mercruiser
STERN DRIVES & INBOARDS

service bulletin

No. 93-5

A. REQUIRED FUEL PUMP PUSH ROD REPLACEMENT

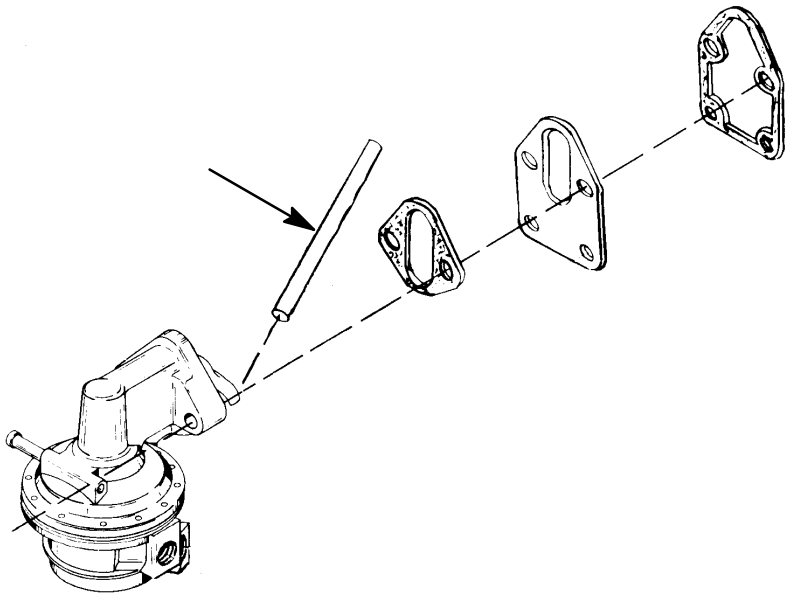
This engine has a steel camshaft in it and it takes a different fuel pump push rod than engines with the cast camshaft. During assembly, the wrong push rod was installed. This wrong push rod can cause premature camshaft fuel pump lobe and/or push rod wear.

The two push rods look alike. Please order the correct push rod by part number and install it in the engine.

(1) 821150 Push Rod
(1) 27-34213 Fuel Pump Gasket
(1) 27-34898 Mounting Plate Gasket
